Project number: 20004
Prepared by: Helen Jenkins/Andy Roberts
Subject: Comments on proposed development at land off Capel Street, Capel-le-Ferne
Date: 15th January 2020 **File no:** 20004.D1a

1.1.1 This technical note has been produced on behalf of Capel-le-Ferne Parish Council to comment on the proposals for 34 residential dwellings off Capel Street (between Nos. 107 to 127). Lime Transport's experience and the qualifications of this report's authors are included at the back of the report.

Swept-path analysis - large car
accessing the private driveways
(sheet 1 of 2)

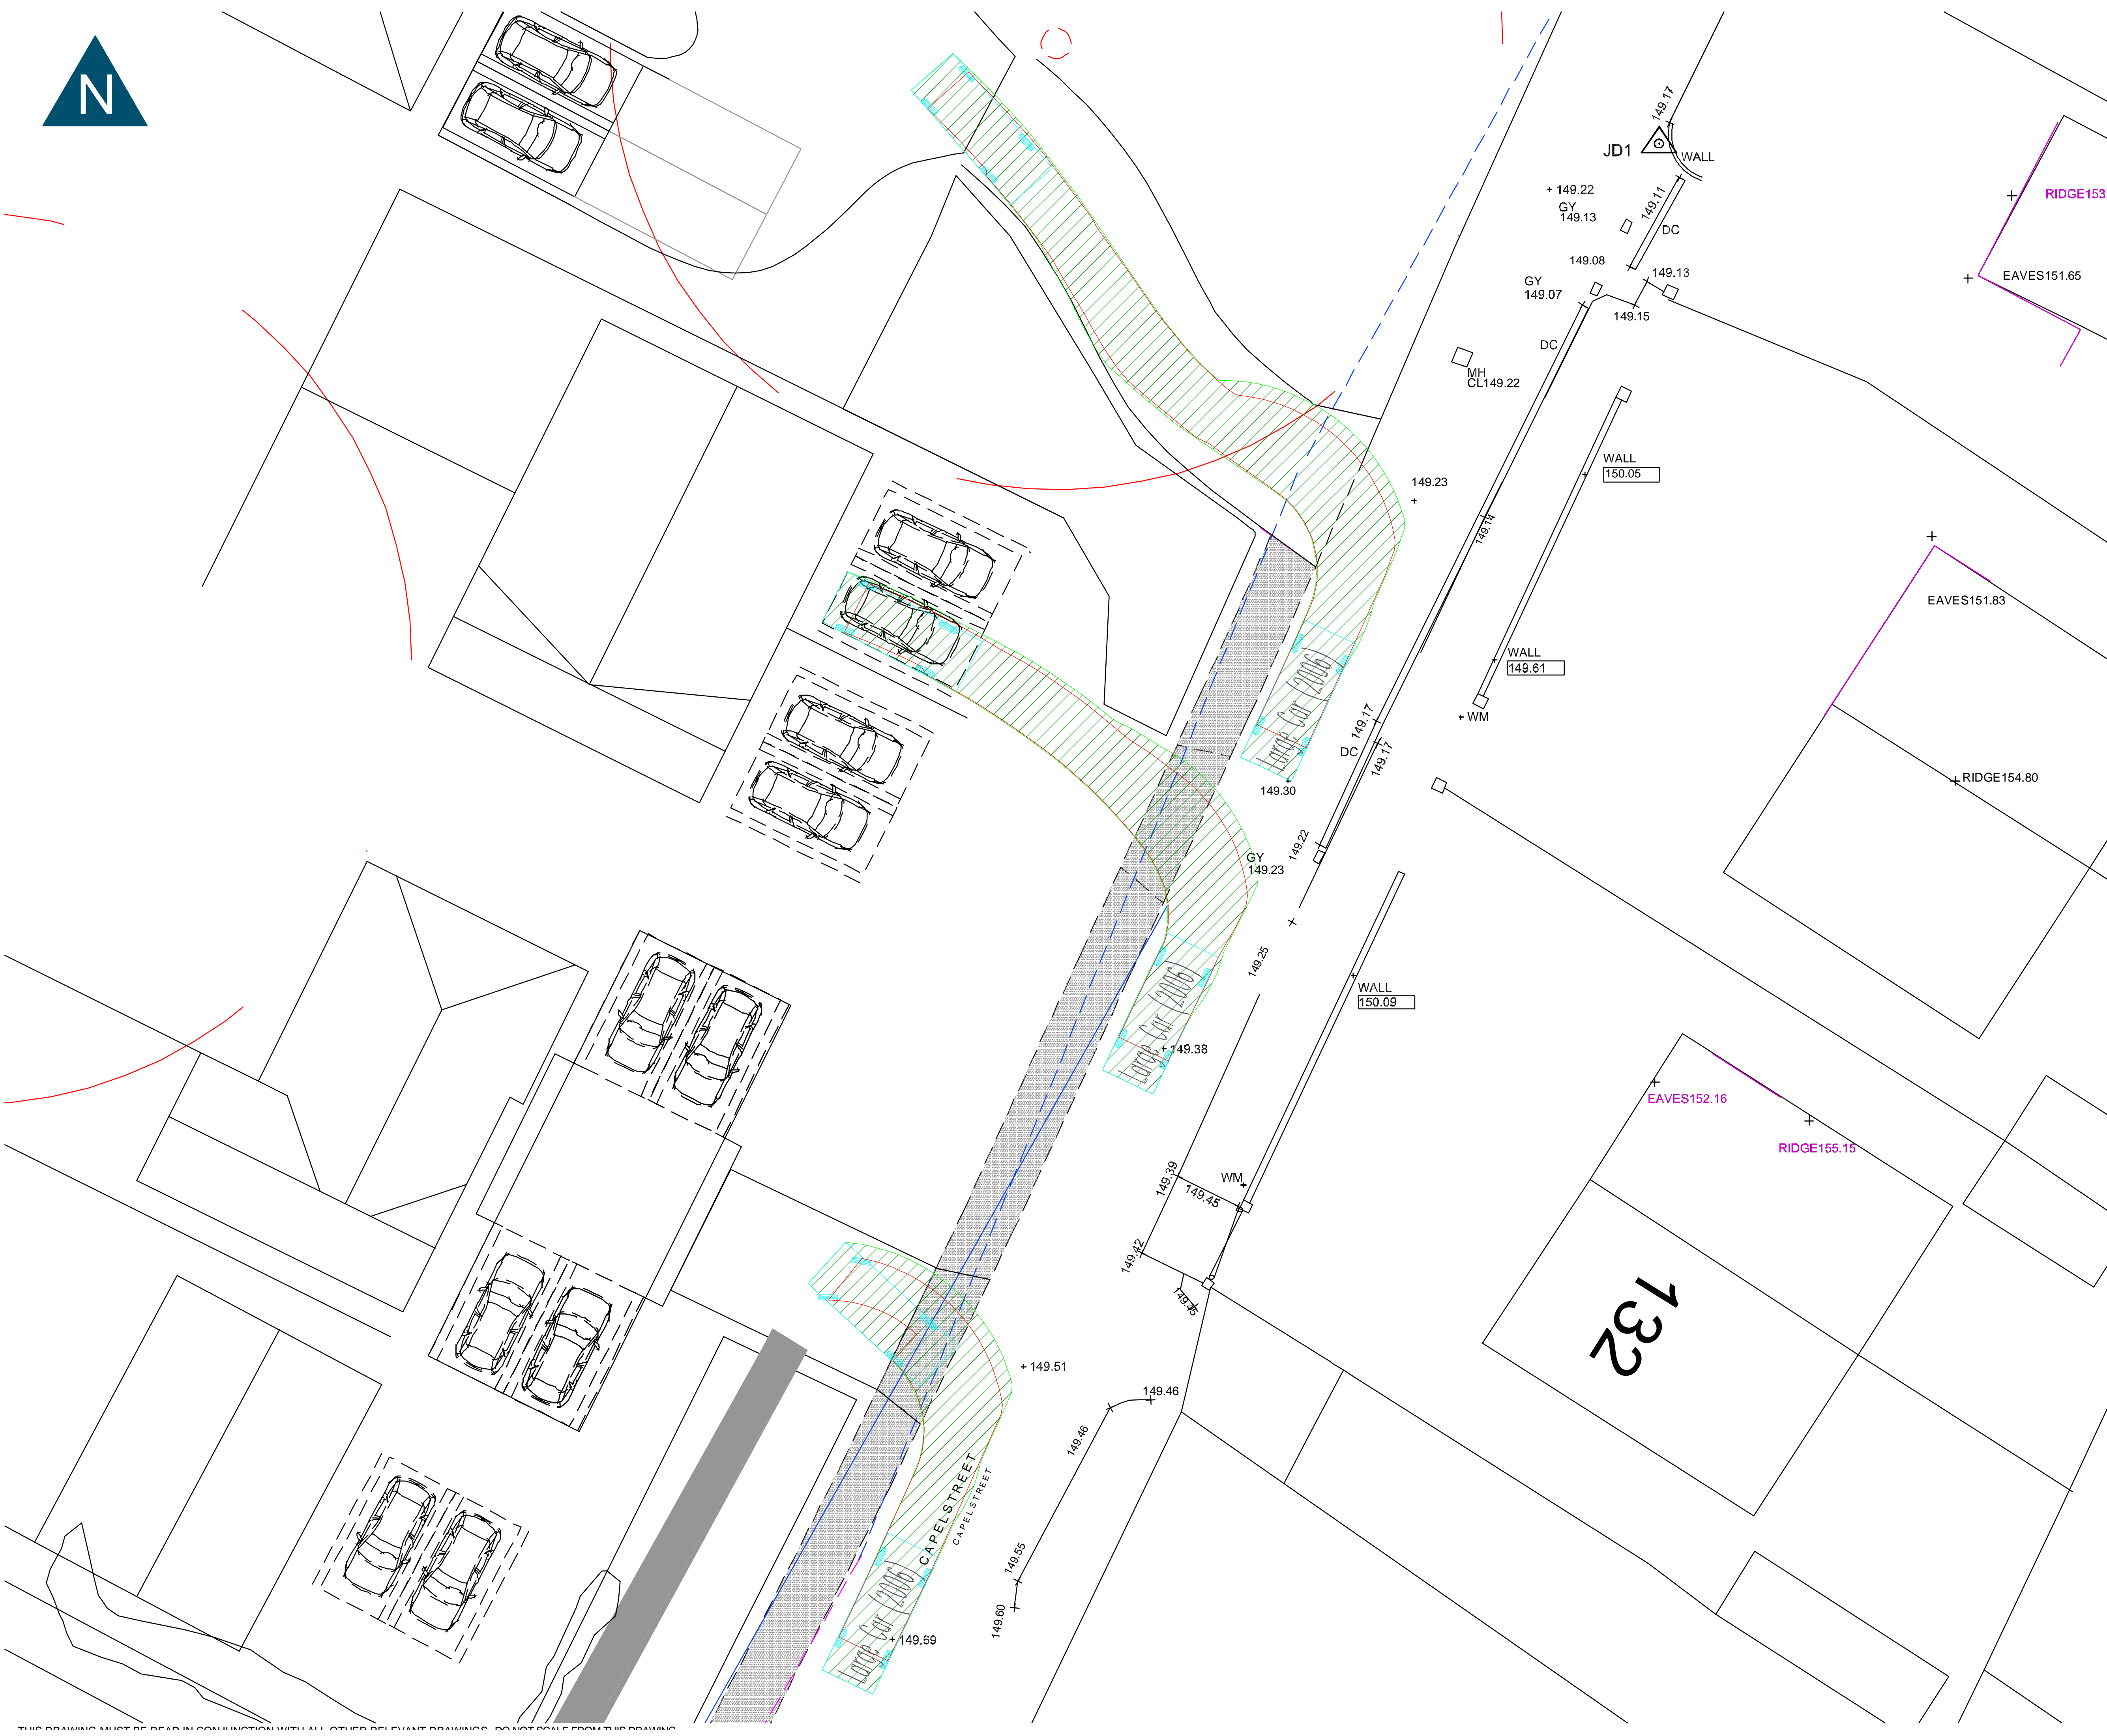
- 2.5.9 In addition, there are no swept-path analyses for any of the shared private drives onto Capel Street, to demonstrate that a large car can access or egress the site without sweeping on to the opposite side of the carriageway, conflicting within a vehicle travelling in the opposite direction of the drive. Swept-path analysis undertaken as part of this review demonstrates that a large car requires the full width of the access at each of the shared private drives (see drawings 20004.TOPO.101.04 and 05). Forward visibility for vehicles turning into these drives is particularly an issue given the proposals to replant the hedgerow.

- 2.5.10 It is also considered that the layout as shown on the Illustrative Masterplan does not show sufficient space within the shared private driveways, particularly the central two private driveways, to allow a car to enter and exit the driveway in a forward gear. This increases the potential for accidents along Capel Street. None of these manoeuvres have been shown on any swept-path diagrams.
